Access Compliance Report

Public Rights-of-Way

Intersection ID: 44207	Main Street: MOCKERNUT_DR	Cross Street: TARTARIAN_CT	Location: NW
ADA ID: DDAD164C3DD3	Ramp Type: PerpDiag	Initial Pass/Fail: Fail	Overall Compliance: No
		Severity Score: 8.75

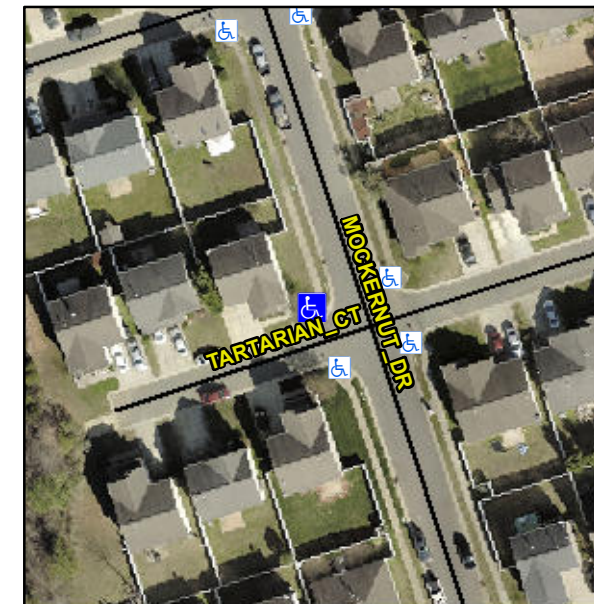
Not Found, R304.5.1

Compliance	Description	Data	Compliance	Description	Data
N/A	Ramp Length (in)	48.5	Yes	Ramp Slope (%)	6.1
No	Ramp Width (in)	47.0	Yes	Ramp XSlope (%)	1.7
N/A	Flare Type LT	N/A	N/A	Flare Type RT	N/A
N/A	Flare Slope LT (%)	N/A	N/A	Flare Slope RT (%)	N/A
N/A	Flare Traversable LT?	N/A	N/A	Flare Traversable RT?	N/A
N/A	Landing Length (in)	N/A	N/A	DWS Provided?	N/A
N/A	Landing Width (in)	N/A	N/A	DWS Contrast?	N/A
N/A	Landing Slope (%)	N/A	N/A	DWS Length (in)	N/A
N/A	Landing X Slope (%)	N/A	N/A	DWS Full Width?	N/A
N/A	Landing Curb? (Y/N)	N/A	N/A	DWS Offset (in)	N/A
N/A	Shared Landing?	N/A			
N/A	Gutter Ponding?	Yes	N/A	Gutter Slope (%)	N/A
N/A	Gutter Lip Ht (in)	N/A	N/A	Gutter X Slope (%)	N/A
N/A	Painted X Walk1?	No	N/A	Painted X Walk2?	No
	X Walk 1 Direction	To S		X Walk 2 Direction	To E
N/A	X Walk 1 Width (in)	N/A	N/A	X Walk 2 Width (in)	N/A
	X Walk 1 Slope (%)	6.3		X Walk 2 Slope (%)	3.2
	X Walk 1 X Slope (%)	1.0		X Walk 2 X Slope (%)	5.1

Remove & Replace Curb Ramp With Two New Directional Ramps or Equivalent.
